## 5.1. MATERIAL CHANGE OF USE FOR A MIXED DEVELOPMENT AT 49 MACROSSAN STREET, PORT DOUGLAS

<b>REPORT AUTHOR(S)</b>	Jenny Elphinstone, Senior Planning Officer
<b>GENERAL MANAGER</b>	Nick Wellwood, General Manager Operations
<b>DEPARTMENT</b>	Development Assessment and Coordination
<b>PROPOSAL</b>	Combined Application - MCU Impact/Code (mixed use development - restaurant, retail, multi-unit housing & holiday accommodation)
<b>APPLICANT</b>	W B Petrie & L H Petrie C/- Planz Town Planning PO Box 181 EDGE HILL QLD 4870
<b>LOCATION OF SITE</b>	49 Macrossan Street, Port Douglas
<b>PROPERTY</b>	Lot 410 on PTD2091

### RECOMMENDATION

**FLOOR PLANS**

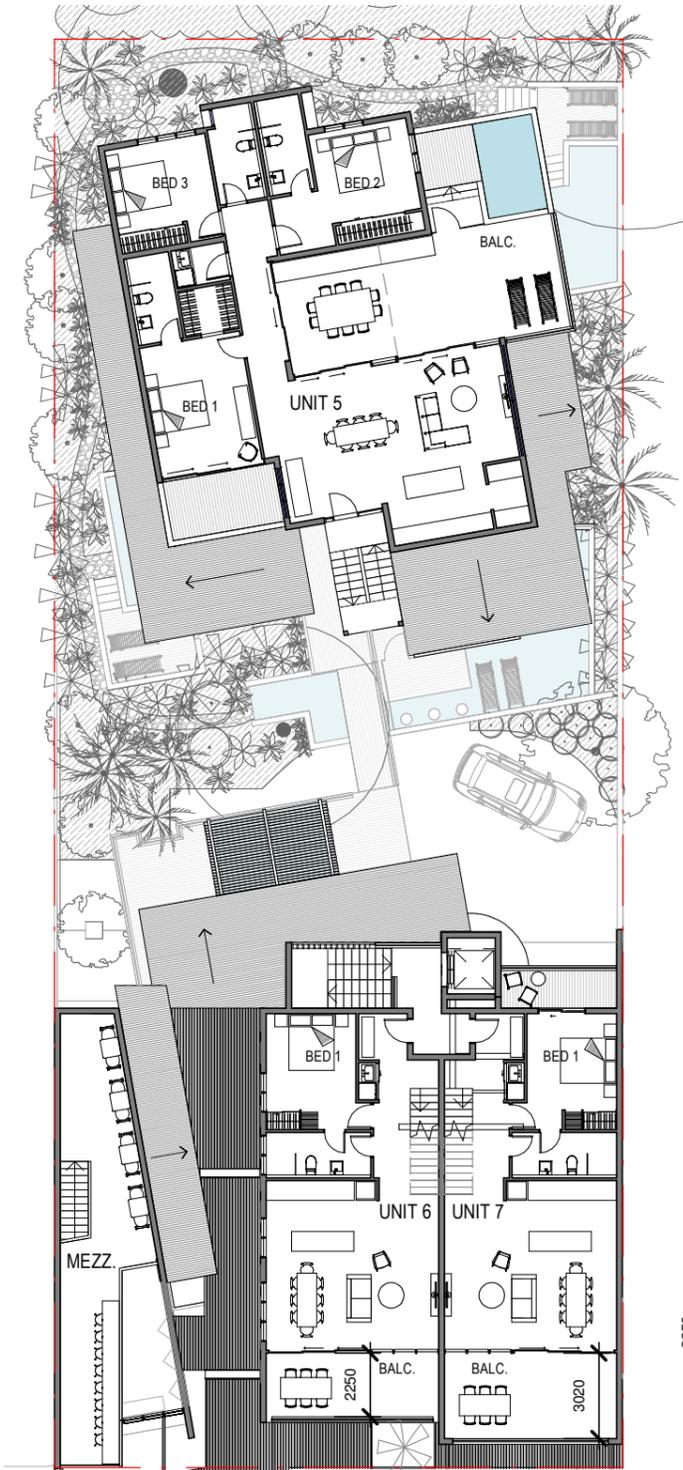
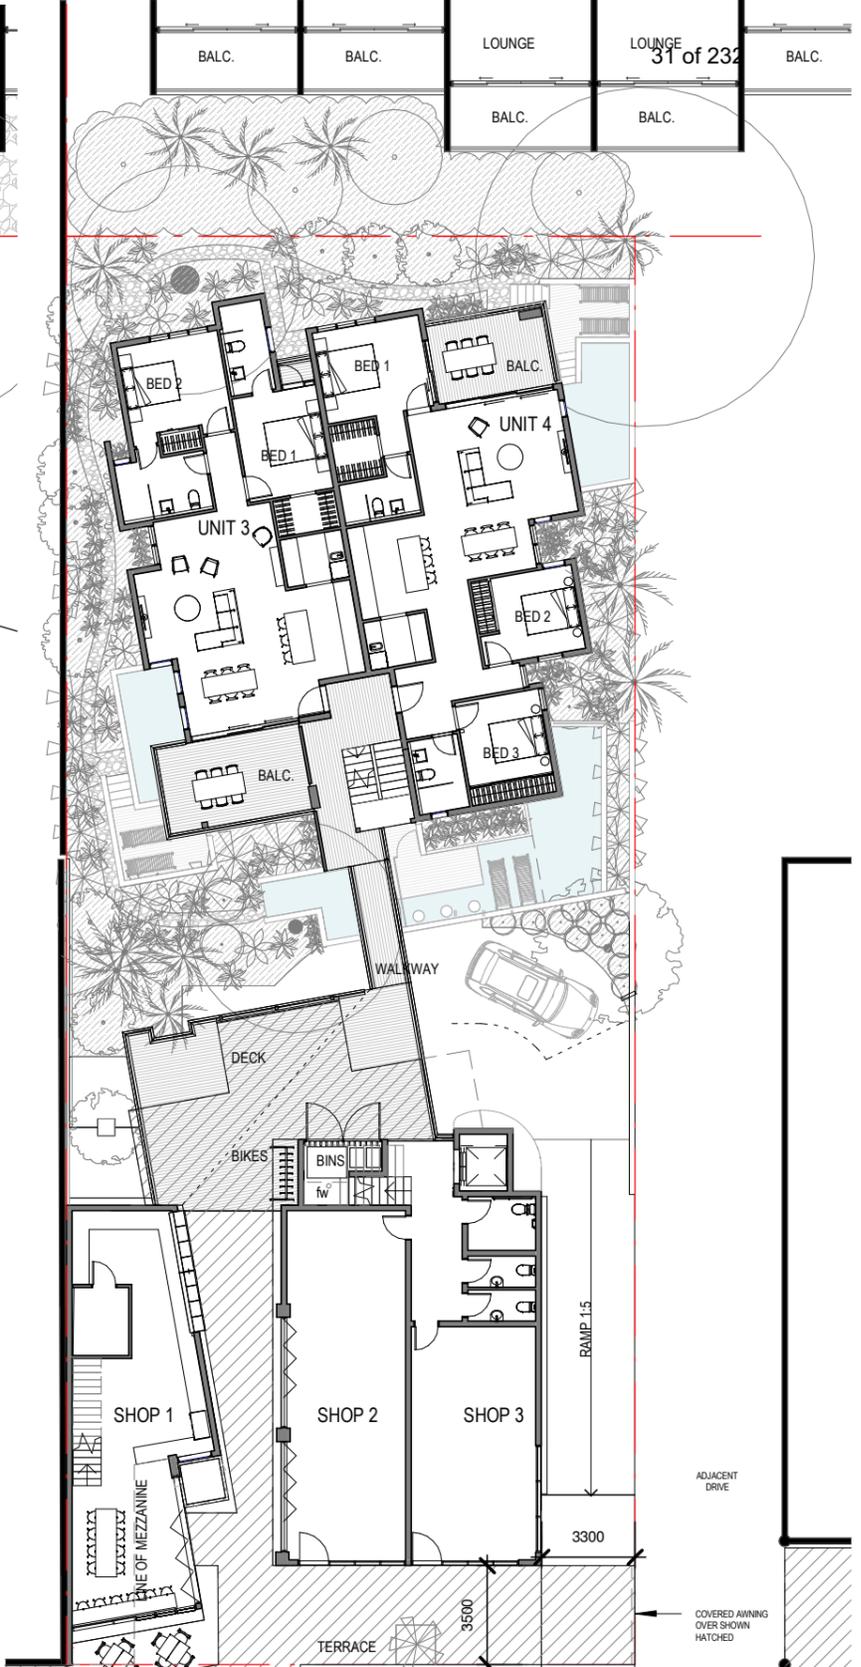
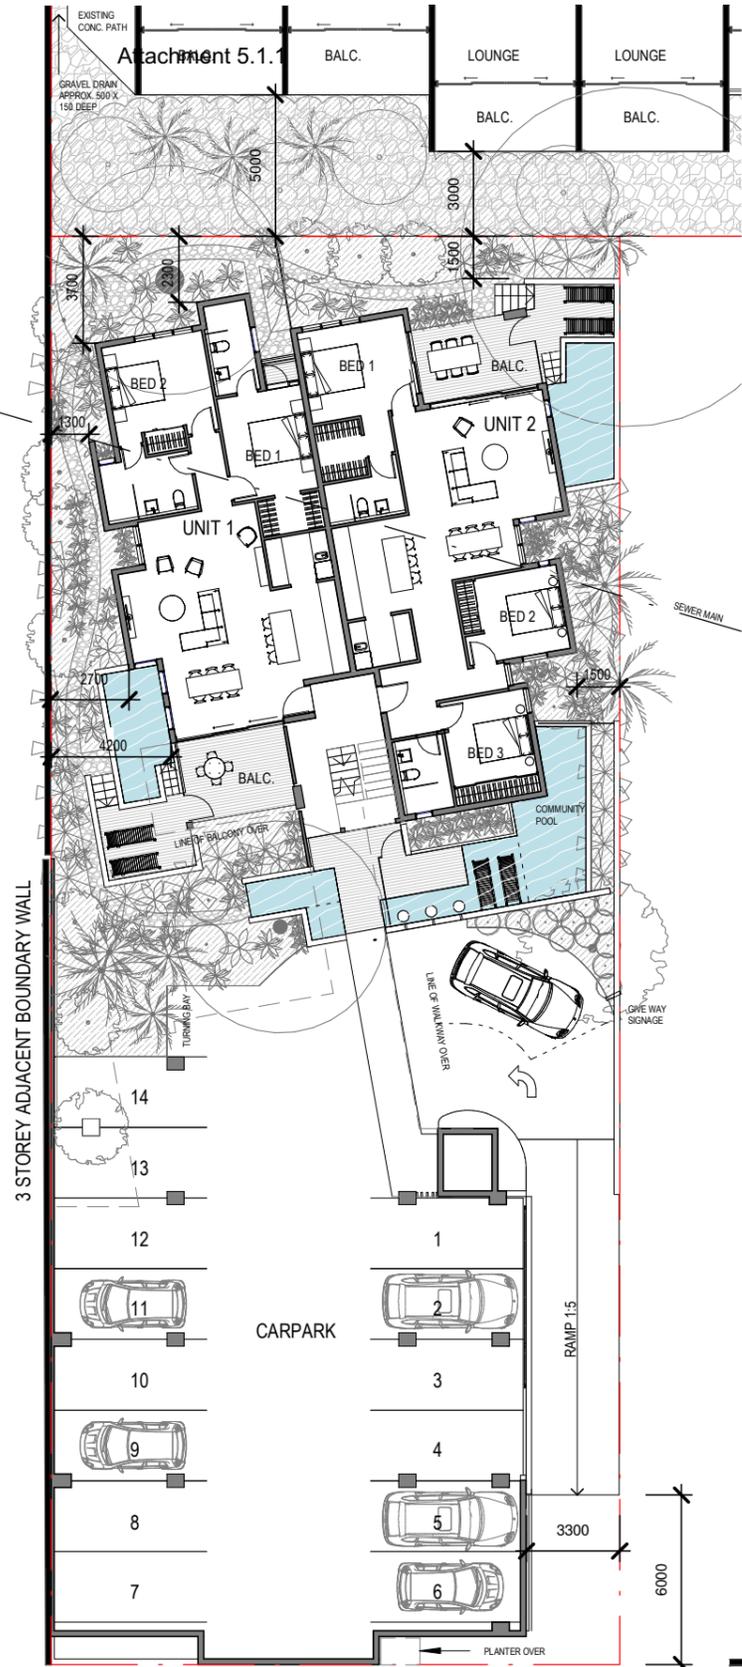
3. The proposed development must be generally in accordance with the Floor Plans, prepared by TPG Architects drawing WLP-01 DA-100H, dated December 2017, (Council electronic document D#838319) and as amended to accommodate the following:

- a. inclusion of at least one disabled driver car parking space;
  - b. provision of a suitable sign advising of limited vehicle access to the basement parking is restricted to Class 1 Vehicle and maximum vehicle clearance heights;

- c. inclusion of suitable traffic warning signs regarding vehicle ramp access and pedestrian activity on sidewalk;
  - d. relocation of the street light to an appropriate position, sufficiently away from the driveway access;

- e. relocation of the utility service manhole away from the vehicle access driveway to a location approved by the utility owner;
  - f. the form of the kerb and channel to the road to match the existing to the neighbouring development to the south-east;

- g. paving of the pedestrian footpath in pavers to match the existing paving to the south-east and to extend in width to match the neighbouring development to the south-east;

- h. the awning to the street be extended to the north-west over the pedestrian sidewalk area, towards the new driveway and to be of a width that provides protection to the width of the pedestrian sidewalk area;**
- i. the Macrossan Street front balconies may only be screened by shutters, glazing, louvres or similar permanent structures to a maximum extent of twenty-five per cent (25%) of their horizontal dimension. The remaining seventy-five per cent (75%) must be capable of remaining open; and**
- j. removal of the dining table and chairs from the adjacent sidewalk area.**

5. The Applicant's amended drawing prepared by TPG Architects, WLP-01, DA-100J, dated 7 March 2018, satisfactorily meets the amended design requirements as listed under Condition 3 parts a, b and h.
